SUMMARY AND RESPONSE TO PUBLIC COMMENTS

Permit No: Aquifer Protection Permit (APP) No. 511633, LTF 61397

Facility Name: Gunnison Copper Project

Prepared By: Arizona Department of Environmental Quality (ADEQ)
Groundwater Section
1110 W. Washington Street
Phoenix, Arizona 85007

Figure 3: Figure 123 from CCA (2016) Appendix G showing the relation of hydraulic conductivity with azimuth between pumping and observation wells.

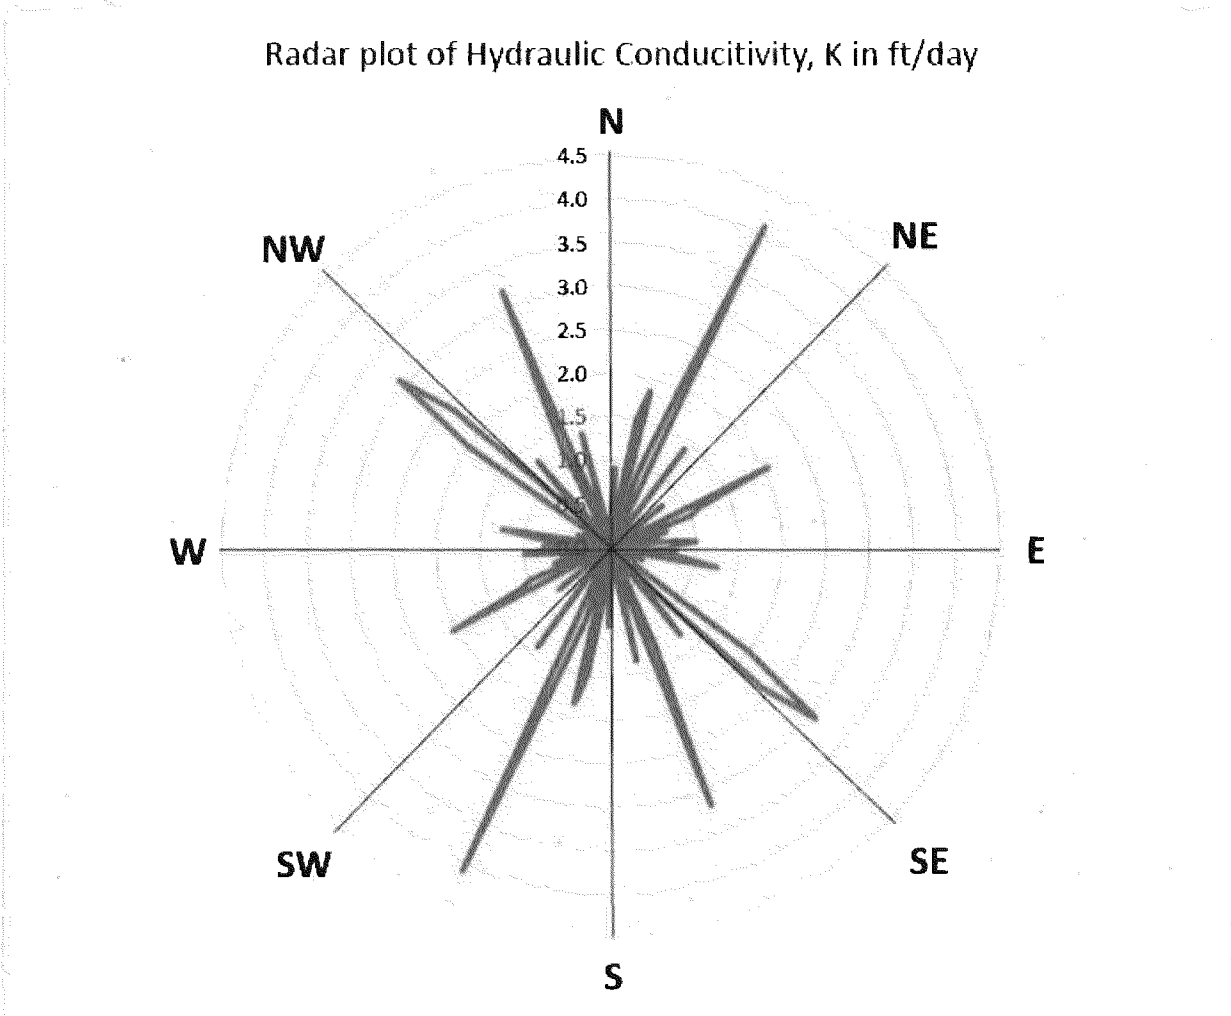
Appendix G presents a directional plot of conductivity with azimuth, which they claim shows they can average the K values without considering direction (Figure 3). Rather than showing "that the hydraulic conductivities are relatively evenly distributed with little prevalent direction" (Appendix G, p 31), Figure 3 shows a substantial correlation with direction. This is especially true for a direction from midway between north and northeast and between south and southwest, where the K exceed 4.0 ft/d, and for a roughly perpendicular direction along which K is just over 3.0 ft/d. Additionally, between those transverse K trends, there is another line of about 3.2 ft/d trending from between north and northwest to between south and

southeast. K in other directions is less than half as much. The trends show a perpendicular fracture pattern, but does not demonstrate that “the fracture patterns intersect sufficiently at the well spacing of 100 feet to smooth out, for the purpose of hydraulics, discrete fracture spacing which is on the order of one foot” (Appendix G, p 31). There is nothing in the Appendix, or anywhere in the Application, that indicates the spacing of the intersection of fracture patterns or of one-foot discrete fracture spacing.

ADEO response to Comment #6.2

The groundwater flow model does consider horizontal anisotropy in its design. The major faults systems are presented with higher hydraulic conductivity values essentially creating anisotropy within the model. This method also accounts for any preferential flow paths (major fault systems) that may be present. In addition, Excelsior provided in the April 2017 "Gunnison Copper Project, Cochise County, Arizona, Aquifer Protection Permit Application Inventory No. 511633 Response to Comments" several figures that show the horizontal area of influence for aquifer testing conducted at the site. These figures indicate the primary preferential flow paths are the major fault systems. These figures include Figure 2-1 "Aquifer Testing Area of Influence, NSH-013", Figure 2-2 "Aquifer Testing Area of Influence, NSH-021C", Figure 2-3 "Aquifer Testing Area of Influence, NSH-024", and Figure 2-4 "Aquifer Testing Total Area of Influence: NSH-013, NSH-021C, NSH-024".

Figure 4: Figure 5-9 from Clear Creek Associates (2017a) showing the wells and coreholes with petroleum hydrocarbon hits.

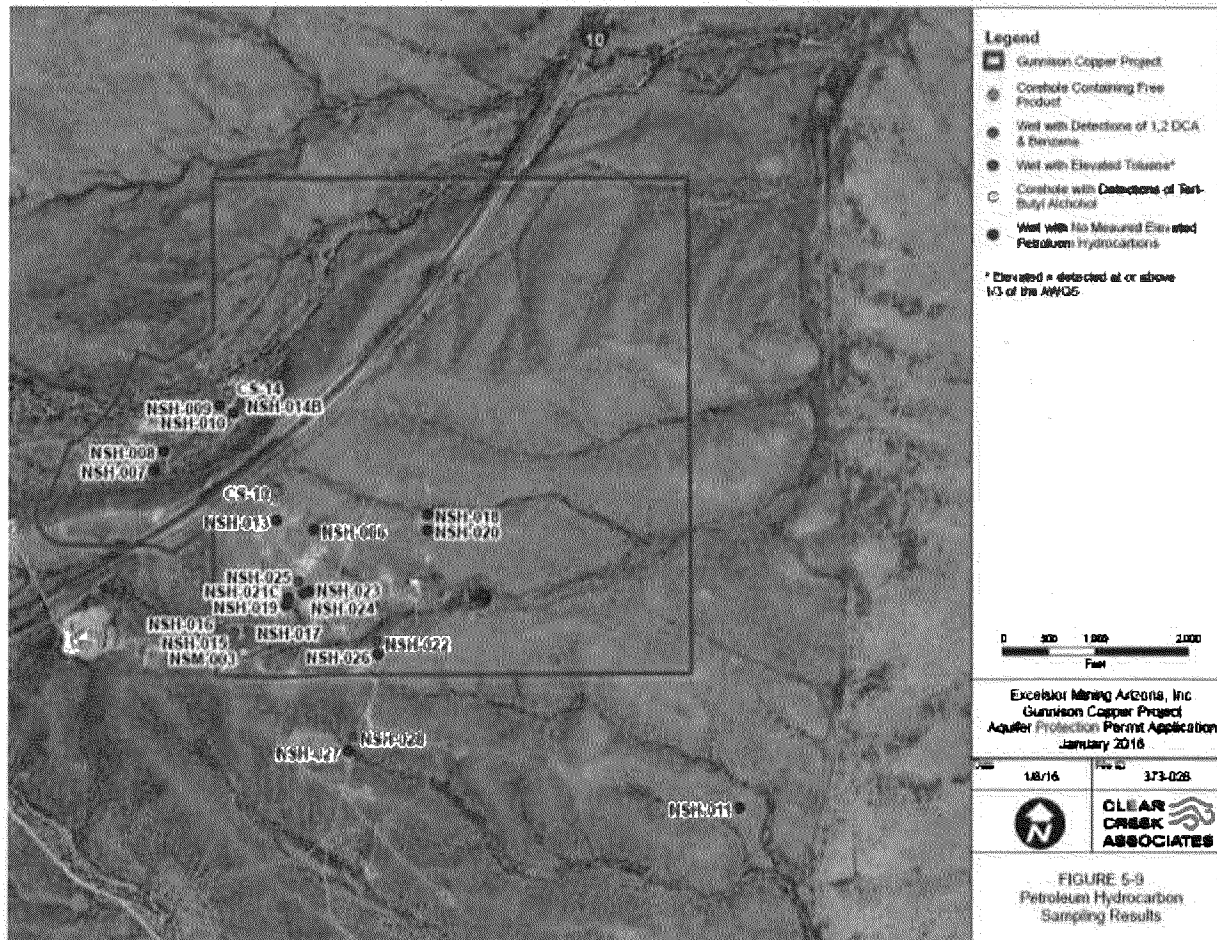
Excelsior explains the potential sources are The Thing gas station and the Johnson Camp Mine, although the mine may not have stored petroleum products (CCA 2016, p 5-9). The Thing site had underground storage tanks removed in 1996 because there had been contamination detected in the soil. ADEQ closed the case files investigating the contamination between the substantial depth to groundwater (hundreds of feet) and the presence of bedrock just two feet below the tanks. Most of the detections (Figure 4) are potentially downgradient of the Thing site (Figure 5). If indeed The Thing is the source, there has been substantial transport and lack of attenuation, which could be a significant source of contamination to the project.

ADEQ does not consider petroleum hydrocarbons a significant issue to liner performance, SX-EW performance or additional impacts to the aquifer. Based upon Excelsior's response to ADEQ comments in June 17, 2016, the hydrocarbons appear to be related to old drilling methodologies which used petroleum fluids during drilling and residual contamination from the former Leaking Underground Storage Tank (LUST) release from "The Thing" near the southwest corner of the site. Mining will extract any remnant hydrocarbons which will then be processed with the other extracted fluids.

Figure 5: Figure 5-10 from Clear Creek Associates (2016) showing the potentiometric surface at the site and to the west and northwest.

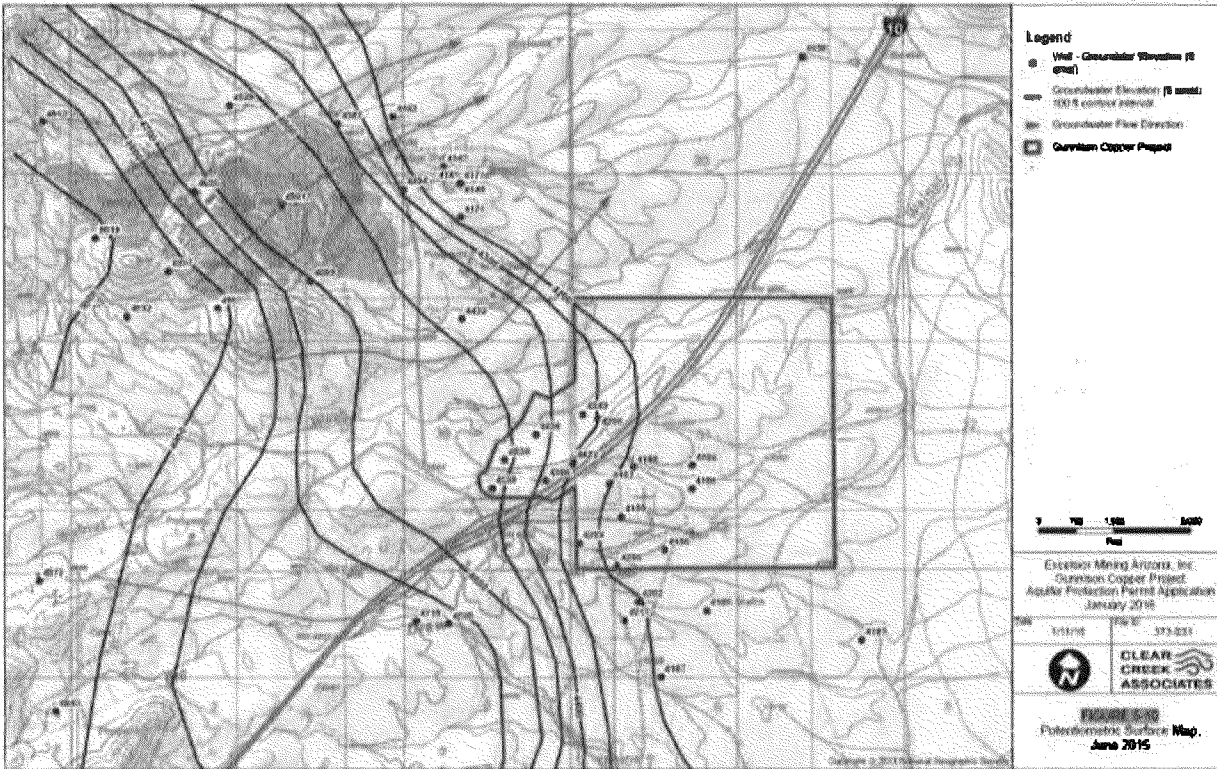
As noted, the mine apparently did not use gasoline, so Excelsior seems convinced that it could not be a source (CCA 2016, p 5-9). They also point to the gradients of the potentiometric surface which suggest that groundwater flow from the mine would be to the northeast and would miss the project site by a mile or more. The potentiometric surface (Figure 5) appears to drop steeply northeast of the mine and appears to form a ridge on the west side of the project site.

- Due to the importance of understanding the source of petroleum products, Excelsior should reconsider the potentiometric surface map to consider whether the water levels used for mapping all represent the same aquifer level. In a fractured rock aquifer, it is not often appropriate to assume there are no vertical gradients. The map with water level with respect to the top of the bedrock (Figure 5-12, CCA 2016a) shows significant variability in small areas, suggesting that it is possible the water levels represent different bedrock levels. It is possible that groundwater flows southeast from the mine at certain levels. For this reason, the mine cannot be ruled out as a source.

Please see response to Comment #6.5.

Figure 7: Figure 5-16 (CCA 2016) showing the point of compliance wells, observation wells, and hydraulic control wells.

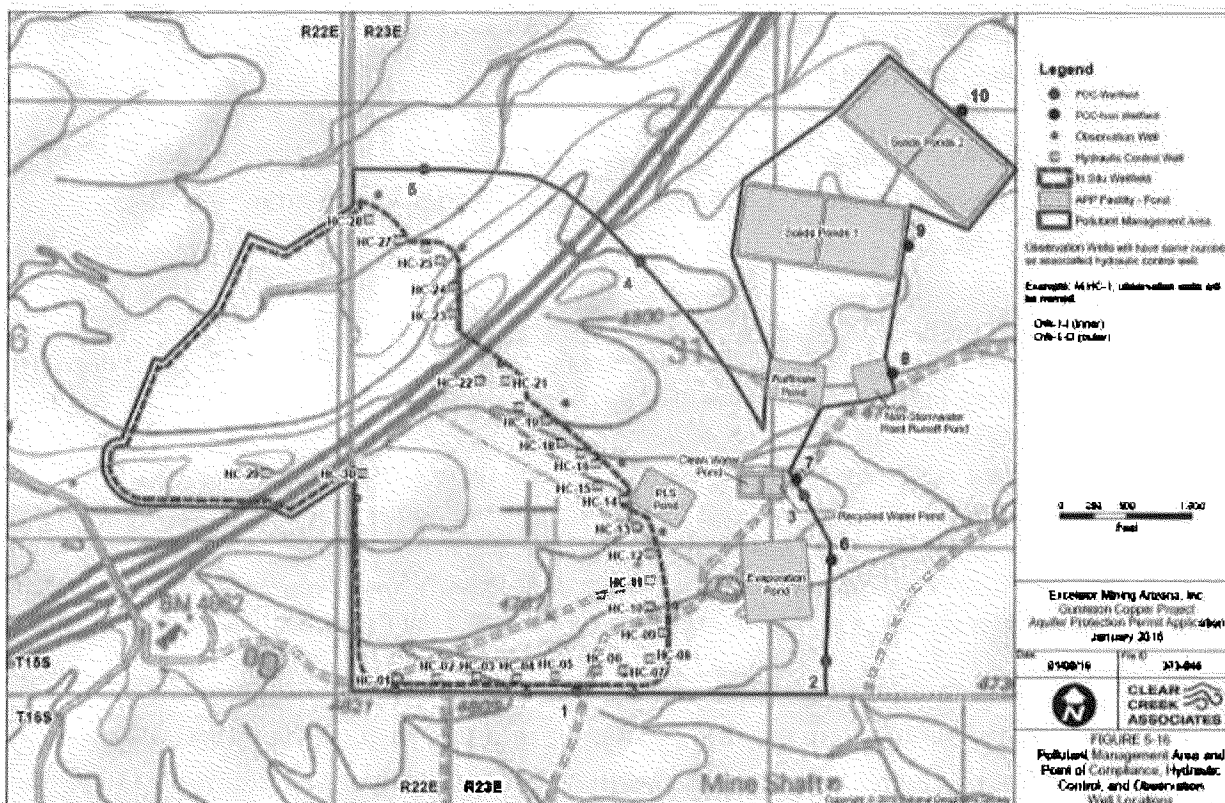
Excelsior proposed five POC wells located outside the area of review (AOR) (CCA 2016, p 5-18) (Figure 7). The AOR is roughly the hydraulic barrier created by the hydraulic control wells. The five POC wells are grossly insufficient for two reasons. First, the wells would be “screened in bedrock, with the top and bottom of the screen set at approximately the same elevations over which the injection wells are open”. This would ultimately be a screen over hundreds of feet, which is grossly insufficient to detect contaminants moving off of the site. Contaminants escaping the site would follow preferential flow pathways, so even if the screened intervals intercept the flow paths, the contaminants would be highly diluted by mixing with groundwater higher and lower than in the aquifer.

Second, five wells spaced along the pollution management area perimeter (Figure 7) is grossly insufficient spacing. Large contaminant plumes could flow between the wells undetected. Also, their placement assumes the potentiometric surface gradient is adequately known to be sure there could be no movement to the south, north, or even west. This is an unsupported assumption because, as discussed elsewhere, heterogeneities and preferential flow paths could cause flow paths that are not perpendicular to the general contours.

There would also be five POC wells downgradient of the impoundments (Figure 7), intended to detect leaks from those impoundments. POC wells 9 and 10 would monitor along the downgradient side of solids ponds 1 and 2. Having just one well for each of these ponds is insufficient because they would only detect contaminants that leak into a flowpath directly upgradient of the well. The size of these ponds should make obvious there are many areas that could contribute contaminants that would not be upgradient of the POC well. These POC wells would detect contaminants that reach the water table through the unsaturated zone, so the source would be at the water table. They would disperse vertically, but not that deeply. The wells should screen the water table and extend below the water table the minimum possible to be sure that water table does not fall below the well. The 60-foot proposed screen thickness is far too large to adequately detect contaminants at the water table because it would allow for cleaner, deeper water to dilute the contaminants.

ADEQ is requiring extensive monitoring near the mine blocks. If, based upon an evaluation of groundwater monitoring data, more POC wells are required, primarily in

the south, then ADEQ will require Excelsior to install and monitor additional POC wells. However, the addition of additional POC wells is not warranted at this time.

Figure 10: Figure 15 from CCA (2016) Appendix I showing the geologic and fracture intensity model.

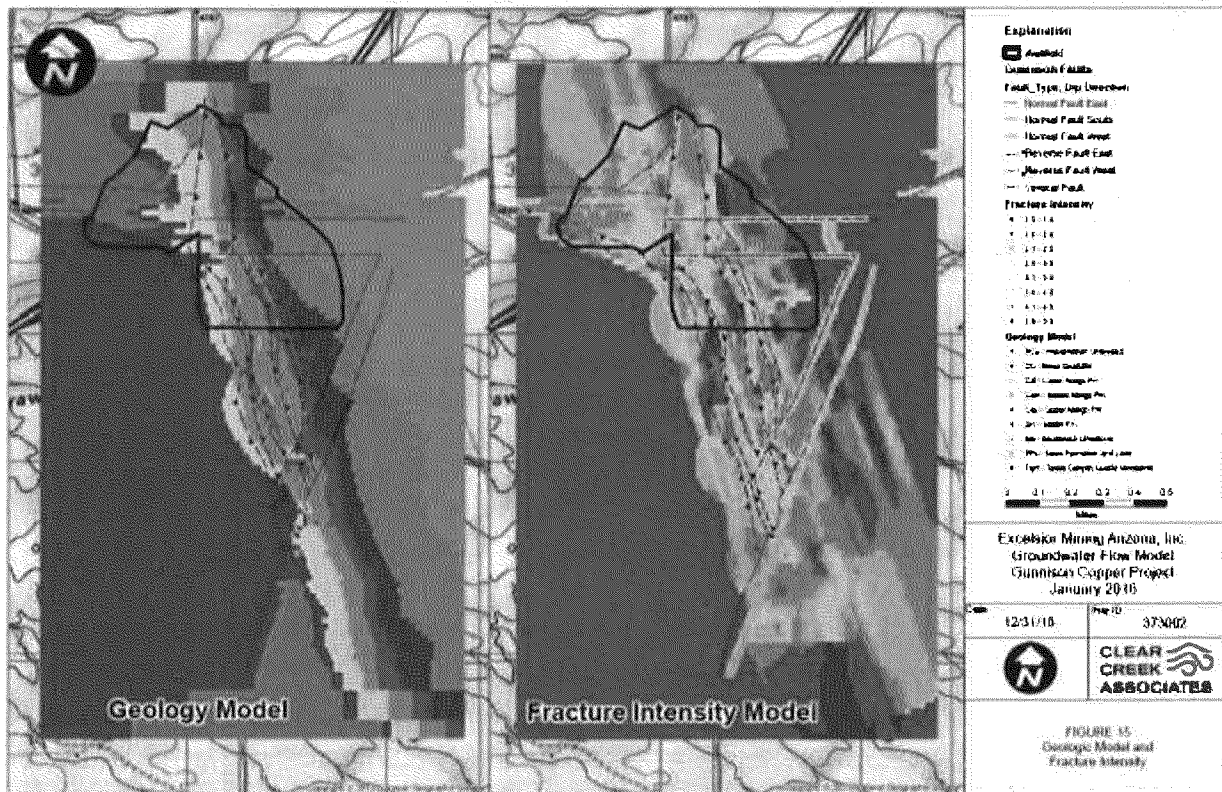
The fracture intensity is much higher in the areas with significant faults, as shown on Figure 10. Faults trends just west of north through the domain south of the project site and curve to a more northwest trend near the site. The yellows and reds on the fracture intensity model is the area of higher fracture intensity. Fracture intensity is much lower west and east of the project area. A model fit shows that conductivity ranges from 1 to about 10 ft/d for the higher fracture intensity (Appendix I, Figure 16).

Figure 12: Figure 32 from CCA (2016) Appendix I showing the calibrated steady state recharge rates around the model domain.

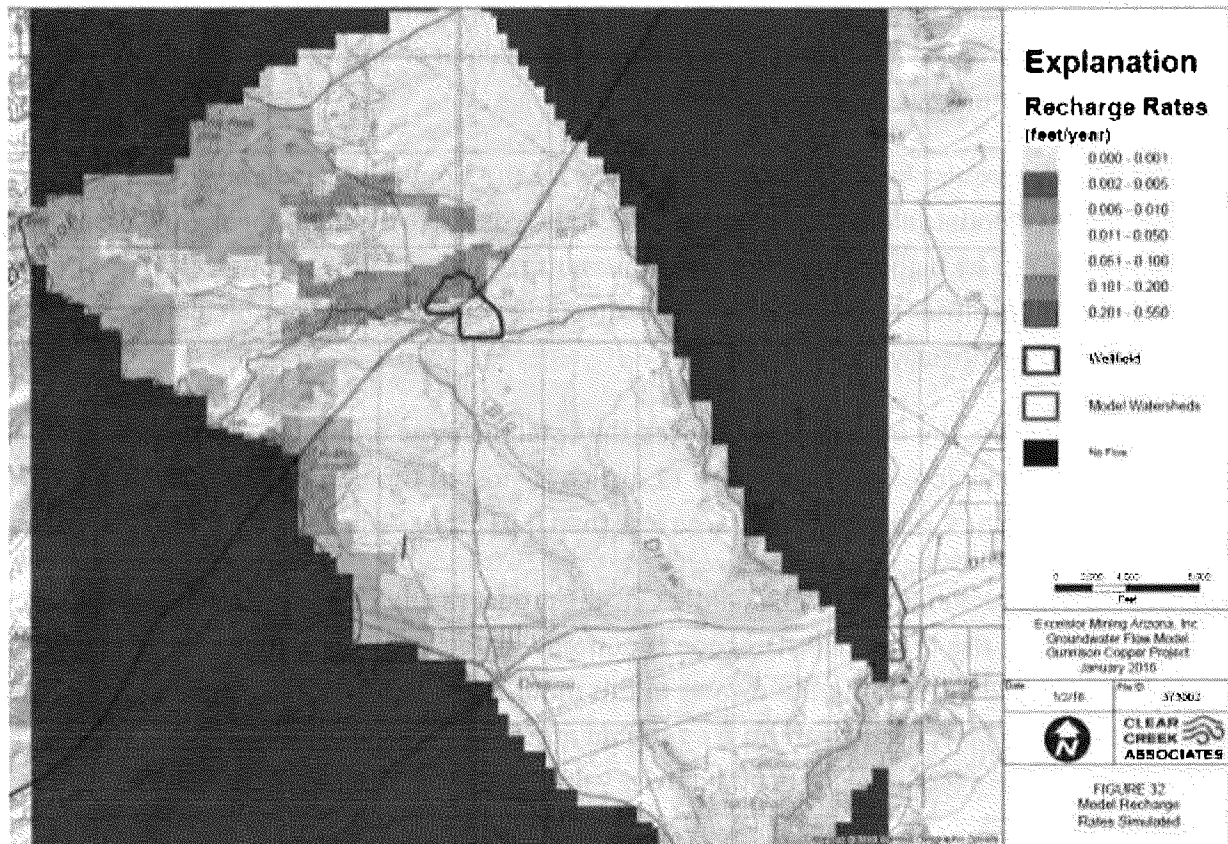
As part of calibration, the modelers distributed the total recharge around the model domain (Figure 12). The noncolored area on Figure 12, which is most of the domain away from the mountains and washes, represents recharge less than 0.012 in/y.

The concentrated recharge may significantly bias the model results. The large zone in orange, west of the project site in the Little Dragoon Mountains, is recharge from 1.2 to 2.4 in/y (Figure 12). Recharge would enter the groundwater in this mountain block only if the geology is highly fractured at the surface, otherwise the area should mostly generate runoff. Much of those mountains have the second highest conductivity values (Figure 13), possibly due to the calibration.

Walnut Wash is a substantial drainage which flows east from these mountains, which indicates there is substantial runoff from the mountains. The model simulates from 0.55 to 6.6 in/y near Walnut Wash west of and within and north of the north quarter of the wellfield. The area is almost 2000 feet wide and over 6000 feet long. The recharge rate into the model domain through the Walnut Wash area is very high, the product of the rate and area shown in red. Most other areas that represent washes are simulated with recharge from 0.12 to 0.5 in/y (green).

Only the smallest recharge rate is used for recharge in the Dragoon Mountains in the southeast. Even if the geology is not conducive to distributed recharge, there should be runoff that leads to mountain-front recharge.

Figure 13: Figure 21 from CCA (2016) Appendix I showing conductivity in model layer 1, the uppermost layer in the model.

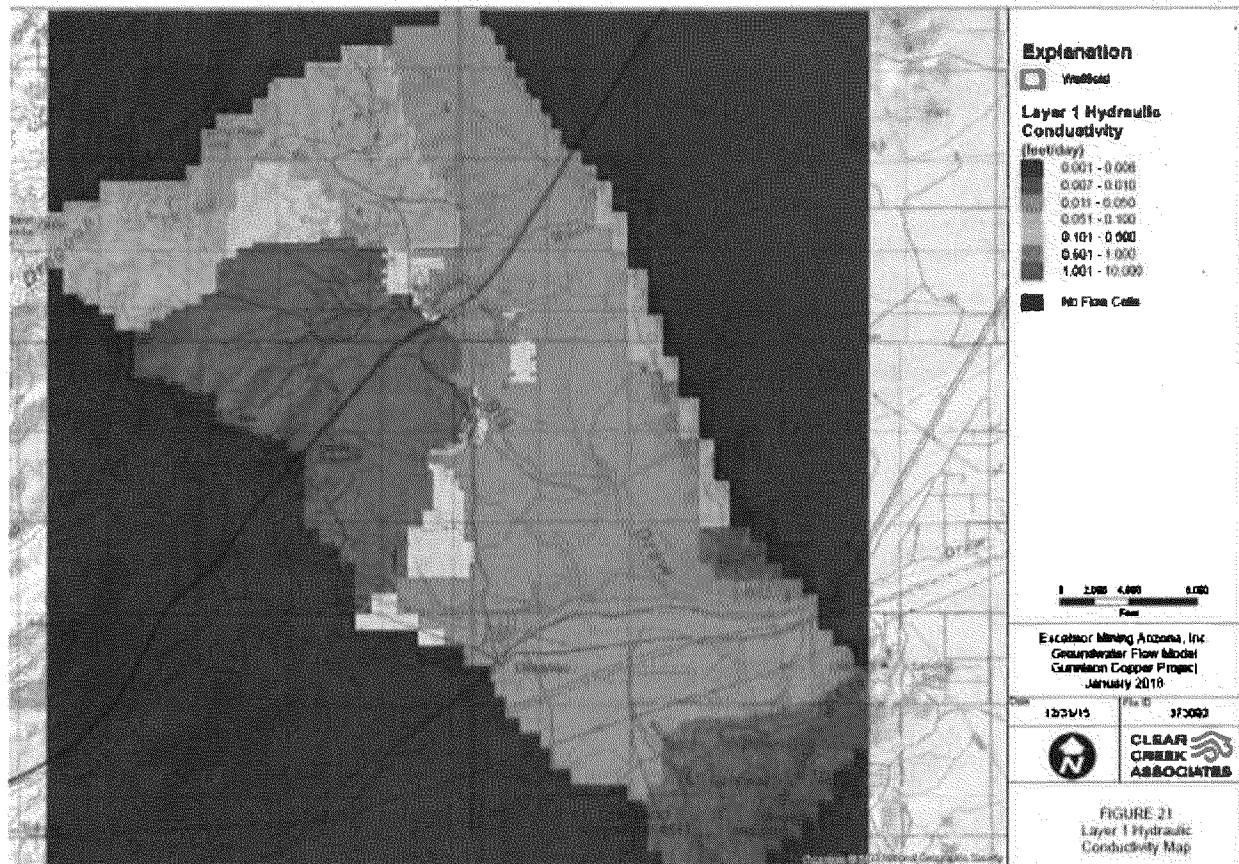
The low K in model layer 1 west of the well field (Figure 13) coincides with the high recharge in

the Walnut Wash (Figure 12). This causes the higher groundwater ridge and steep slopes seen in the modeled steady state contours (Figure 14). Much of the remainder of the high recharge zones west of the project coincides with higher conductivity material in layer 1.

Figure 14: Figure 33 from Appendix I showing groundwater elevation contours, residuals at observation wells, and residual statistics.

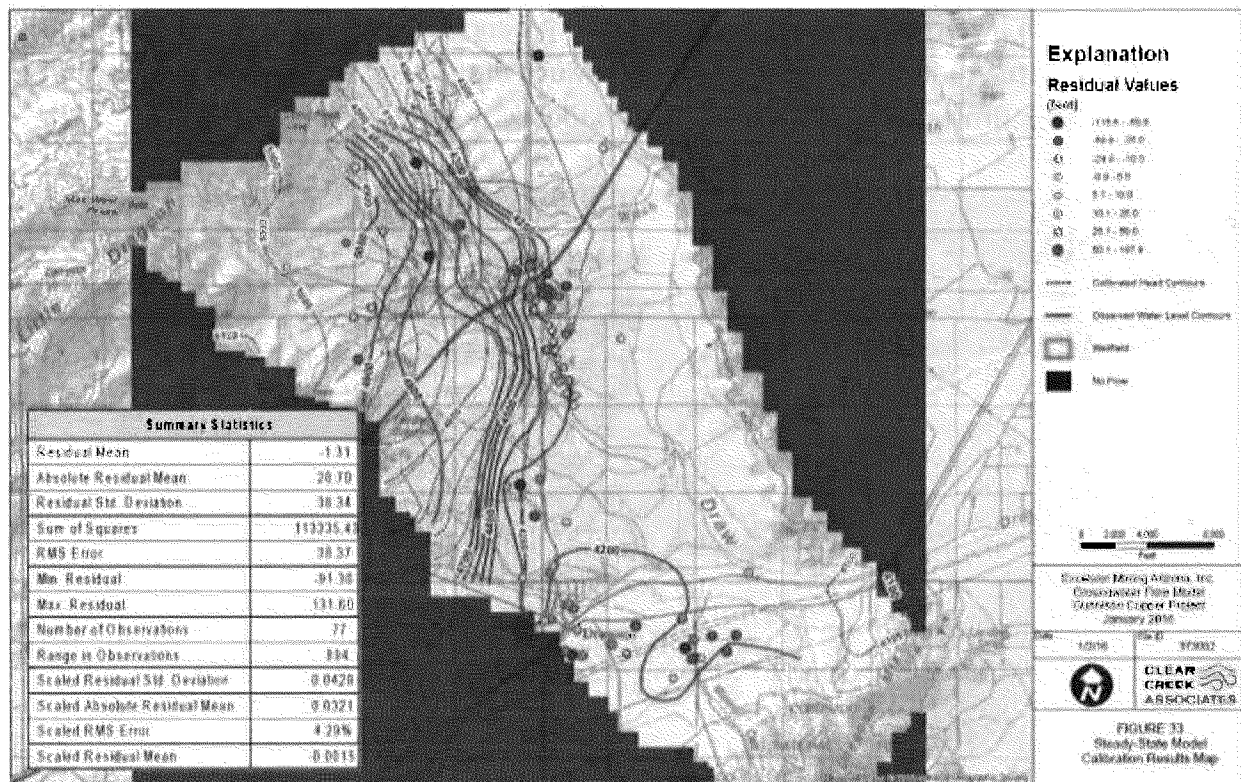
Figure 14 shows simulated and observed groundwater contours and residuals resulting from the final calibration. A residual is the difference between simulated and observed values. The simulated heads have a much more consistent gradient and resemble a surface much more than the observed heads. This probably reflects how the model layers represent average values over several fracture zones whereas the observation wells are monitoring different fracture zones. Simulated contour 4200 ft lies a couple thousand feet east of the observed 4200 ft contour which means the simulation results in a potentiometric surface above the observed.
